Edwards Aquifer Habitat Conservation Plan Nonroutine Adaptive Management Proposal

To: EAHCP Committees
From: Nathan Pence, Program Manager
Date: September 1, 2016
Re: Submerged Aquatic Vegetation Restoration Programs

EXHIBIT C

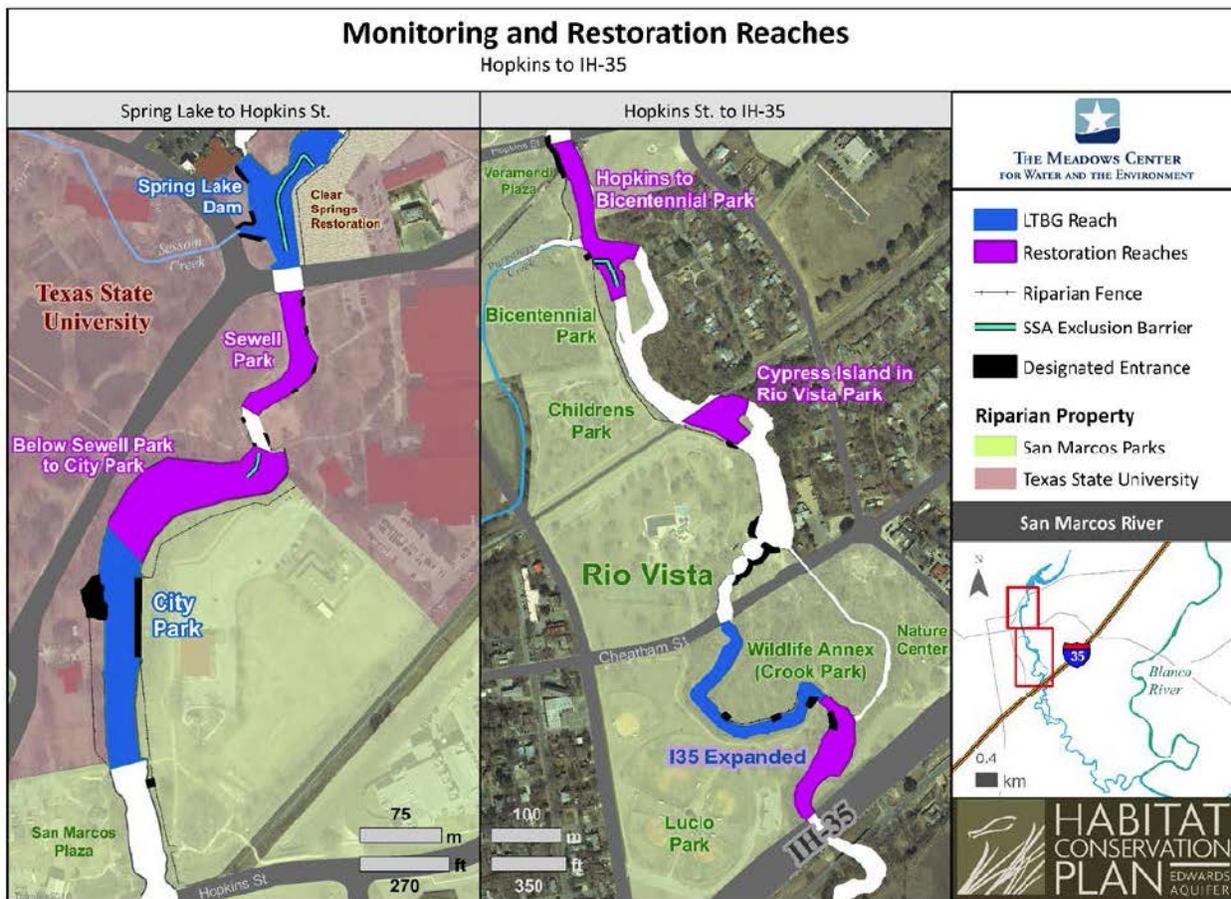
- Identification of geographic locations of restoration reaches¹ (Exhibit C). These locations were chosen to complement existing LTBG reaches (prevent fragmentation and reestablishment of non-natives) and to address areas of concern (large stands of non-natives).

Defined “restoration reaches” to define “proportional expansion”
in the Comal River.

Long-term Biological Goal reaches and proposed “restoration reaches” for the Comal system.
